ULNRC-05779

**DOCKET NUMBER 50-483
CALLAWAY PLANT UNIT 1
UNION ELECTRIC CO.
FACILITY OPERATING LICENSE NPF-30
LICENSE AMENDMENT APPLICATION SUPPLEMENT FOR A
TECHNICAL SPECIFICATION CHANGE THAT WOULD RELOCATE
SPECIFIC SURVEILLANCE FREQUENCIES TO A LICENSEE
CONTROLLED PROGRAM (LDCN 10-0020) (TAC NO. ME4506)**

Proposed Technical Specification changes to the submittal provided in ULNRC-05725.

Proposed Technical Specification Bases changes to the submittal provided in ULNRC-05725.

SR 3.7.2.2

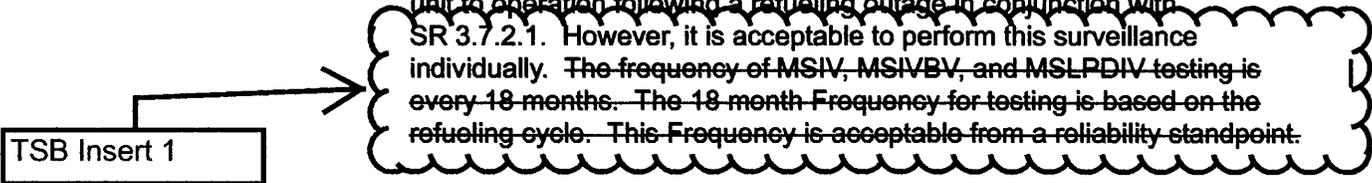
The Bases for TS 3.7.2 was revised to include the MSIVBVs and MSLPDIIVS in revision 9 attached. Replacing this page with the markup of TSB 3.7.2 attached.

This SR verifies that each MSIV, each MSIVBV, and each MSLPDIV is capable of closure on an actual or simulated actuation signal. The manual fast close handswitch in the Control Room provides an acceptable actuation signal. For the MSIVs each actuation train must be tested separately. This Surveillance is normally performed upon returning the unit to operation following a refueling outage in conjunction with SR 3.7.2.1. However, it is acceptable to perform this surveillance individually. ~~The frequency of MSIV, MSIVBV, and MSLPDIV testing is every 18 months. The 18-month Frequency for testing is based on the refueling cycle. This Frequency is acceptable from a reliability standpoint.~~

TSB Insert 1

SR 3.7.2.3

This SR verifies that the closure time of each MSIVBV and MSLPDIV is ≤ 15 seconds when tested pursuant to the Inservice Testing Program. This is consistent with the assumptions used in the accident and containment analyses.
